RESPONSE TO SUBMISSIONS: PROPOSED MANUFACTURING FACILITY AND ASSOCIATED WAREHOUSE

657-769 MAMRE ROAD, KEMPS CREEK
LOT 10 APPROVED UNDER SSD 9522

18 August 2022

SSD-25725029

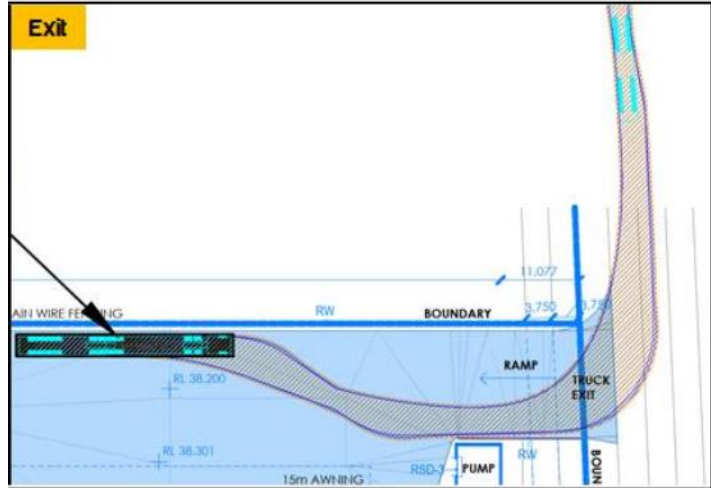
SUBMITTER	MATTERS RAISED	COMMENTS / REQUESTS	FORMAL RESPONSE
		<p>Vehicular driveways and crossovers are to be wholly contained within the development frontage so as not impact upon any future adjoining development.</p> <p>Revised turn path diagrams are to be provided demonstrating compliance for the following:</p> <ul style="list-style-type: none"> Site access for 30m Performance Based Standards (PBS) Level 2 Type B vehicles and tested for a 36.5m PBS Level 3 Type A vehicles <p>Widths of the verge and road pavement lanes of the adjoining Public Access Roads 1 and 3 shall comply with the engineering plans submitted for the SSD-9522 MOD2 application. Full details are to be provided.</p>	 <p>Figure 2 Truck Exit Swept Path (Source: Ason Group, 2022)</p> <p>All vehicular driveways and crossovers have been amended to be within the development frontage.</p> <p>The entry and exit vehicular driveways have been splayed in order to accommodate the vehicular movements of the 30.0m Super B-double truck and 36.2m A-double truck as well.</p> <p>It is emphasised that the largest size truck is expected to be a 26.0m B-Double truck, however, the assessment has been based on a 30.0m Super B-Double truck which is deemed conservative. Furthermore, the swept path assessment</p>

SUBMITTER	MATTERS RAISED	COMMENTS / REQUESTS	FORMAL RESPONSE
		The Department is to be satisfied that the applicant's Environmentally Sustainable Design (ESD) report provides details as to the measures which will be implemented as a result of the development and what outcomes will be achieved by such measures.	
	Development Engineering Considerations	<p>a. Development Engineering Traffic Matters</p> <p>The widths of the vehicle driveways, crossovers and laybacks for heavy vehicles within the public verge areas as shown on the architectural plans, differ to the engineering plans.</p> <p>Turn path diagrams provided in the Transport Assessment report by Ason Group dated 05.11.2021 show a Super B-Double Quad-Quad heavy vehicle entering and exiting the site by encroaching over the frontage of the adjoining lot within the verge area, which is not supported.</p>	<p>The external roads are designed for the 30m Super B-double as per SSD 9522 (Condition A6). Further the design has been tested for the 36.5m PBS Level 3 & 4 vehicle as required of the MRP DCP.</p> <p>It is emphasised that the largest size truck is expected to be a 26.0m B-Double truck based on the tenant's advice, however, the assessment has been based on a 30.0m Super B-Double truck which is deemed conservative.</p> <p>Furthermore, the 30.0m Super B-double truck does not enter and exit the Site by encroaching over the frontage of the adjoining lot. Rather, the vehicle enters and exits over the proposed vehicular crossovers that have been shown on the plans, as shown in Figures 1 and 2 below.</p>

TABLE 1: RESPONSE TO AGENCY SUBMISSIONS			
SUBMITTER	MATTERS RAISED	COMMENTS / REQUESTS	FORMAL RESPONSE
			<div> <div>Entry</div> </div> <p>Figure 1 Truck Entry Swept Path (Source: Ason Group, 2022)</p>

Figure 7 Operation Process Flow (Source: Ardex, 2021)

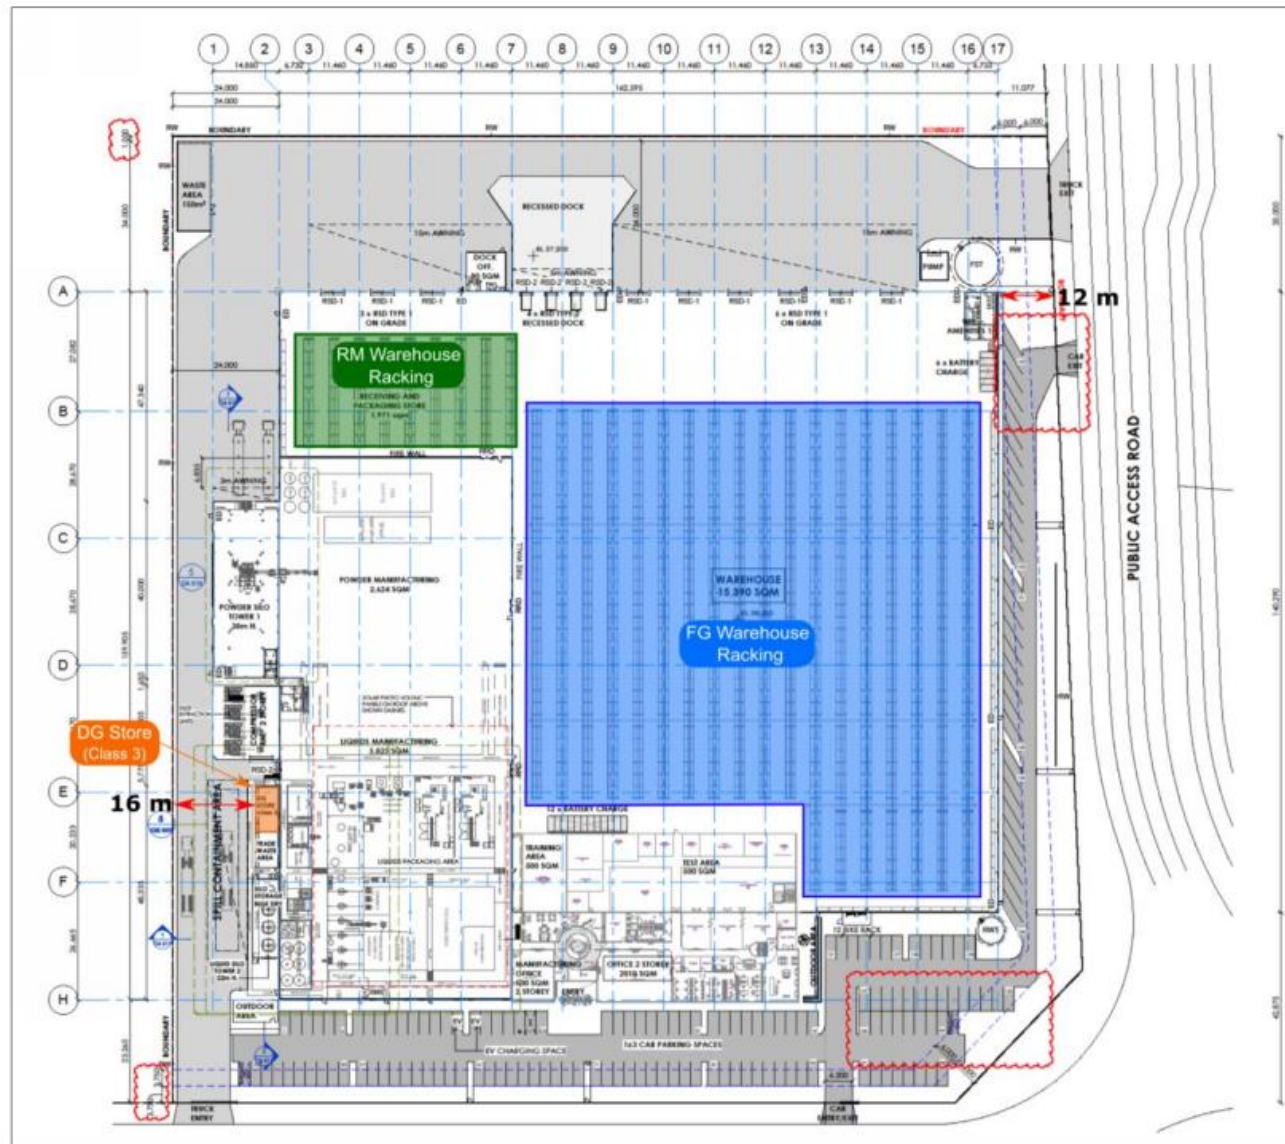
The Department notes Figure 16 in the EIS is not legible. The RtS must include updated and legible figure.	An updated Figure 16 has been reproduced below as Figure 7 of this RTS
		The EIS and Civil Report propose indicative finished site levels of +/- 500 mm. Where finished site levels and building heights are unknown, the worst-case scenario should be assessed. The RtS and relevant technical assessments including but not limited to the Architectural Plans, Visual Impact Assessment Report and Civil Report should be revised.	Updated development statistics have been provided within Table 2 of this RTS and the relevant technical assessments have been updated to include the worst-case scenario having regard to building height.

Figure 9 Amended Intersection Layout (Source: Ason Group, 2022)

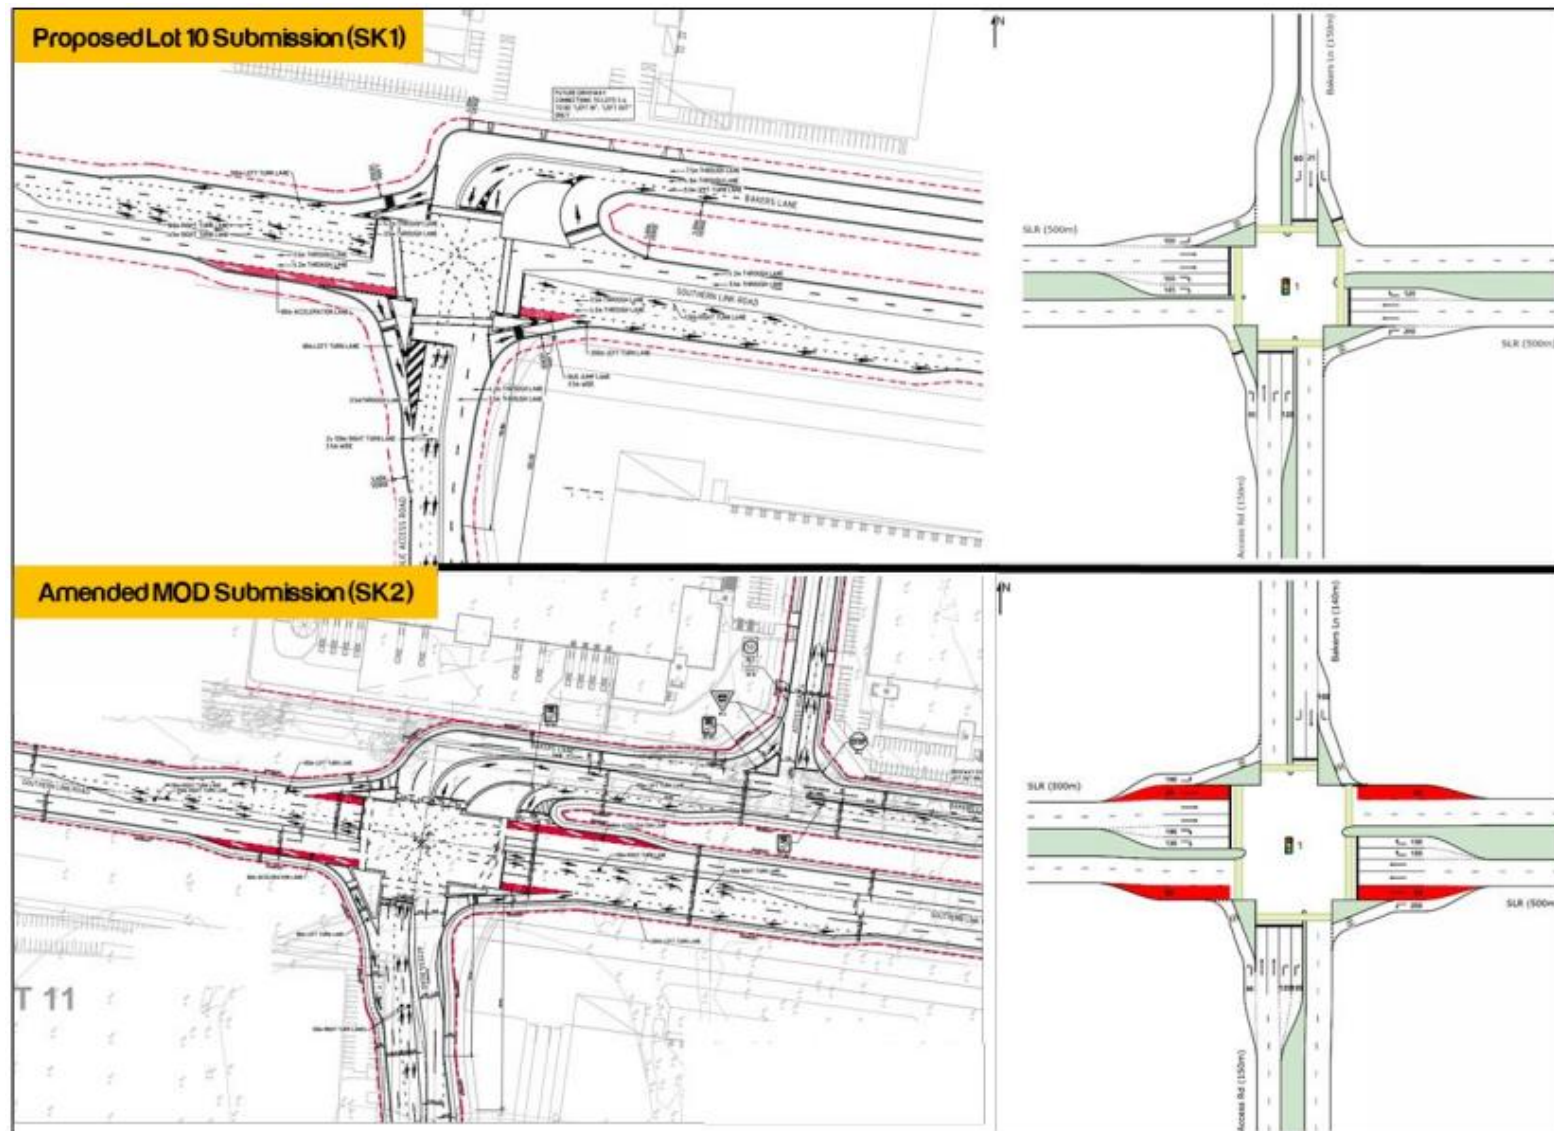
<p><u>Comment</u> Section 6.7 - future SLR /Bakers Lane/NS Road 01 - It should be noted that the layout of this intersection is not supported by TfNSW. TfNSW has provided preliminary guidance on the 3 November to the applicant and DPIE regarding the layout and modelling of this intersection (Attachment B). This guidance was</p>	<p>Consultation regarding the design of this intersection in appreciation of Lots 1-4 (to the north of Bakers Lane) has been undertaken with TfNSW as part of a separate Modification application.</p>

Figure 11 Wastewater Treatment Process (Source: Baldwin, 2022)

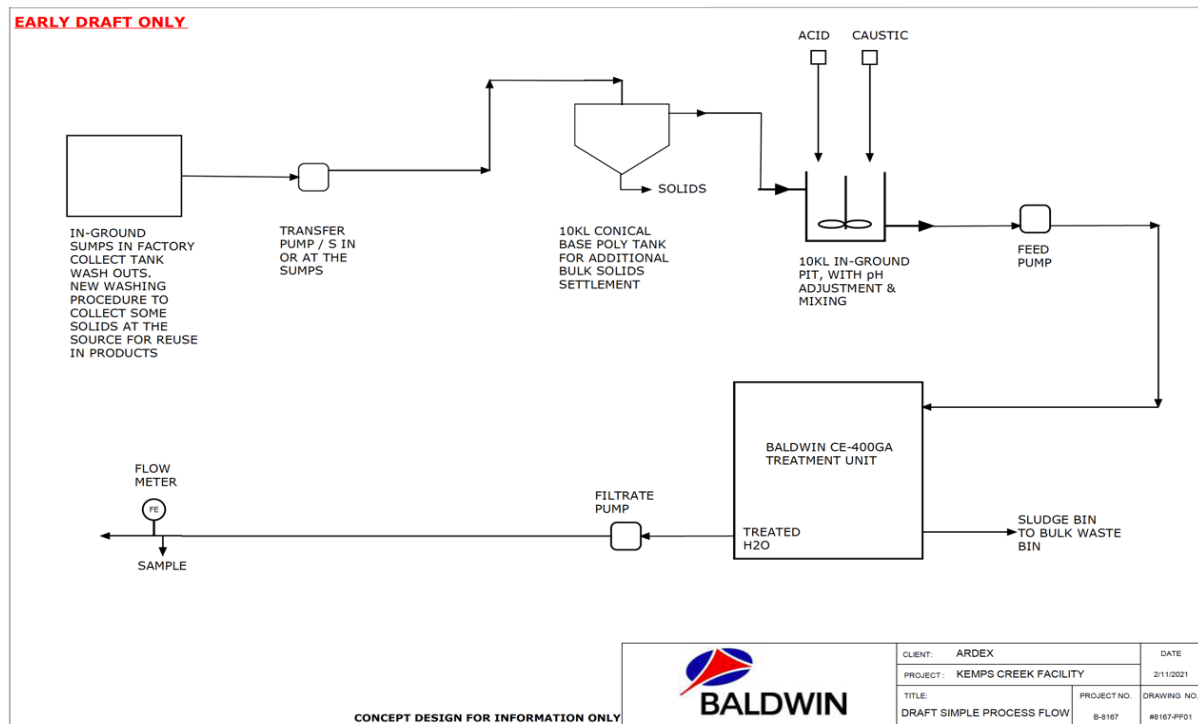
The Department notes that a wastewater treatment plant is proposed. The Department notes the EIS does not discuss in detail how the wastewater treatment plant would operate including the volumes of wastewater that would be treated and discharged. The Department considers the detail provided on the architectural plans to be concept only. The Department requires that the details of the construction and operation of the proposed wastewater treatment plant is included in the revised EIS and relevant appendices and the plans to be revised. The Department notes the detail of the proposed water treatment plant within the Noise and Vibration Impact Assessment (NVIA) is not sufficient. The NVIA is to be updated also.	<p>Details of the proposed wastewater treatment plant have been appropriately provided in Section 4.3 of this RTS.</p> <p>In addition, further details of the proposed water treatment plant have been included in the updated NVIA (Appendix C6 of this RTS), following consultation with the manufacturer.</p> <p>The key noise source of the pumps for the system are likely to be either centrifugal or submersible pumps for the filtrate and feed pumps. These are substantially quieter, and do not contain the annoying characteristics exhibited by</p>

The wastewater treatment process is depicted below in **Figure 11**.
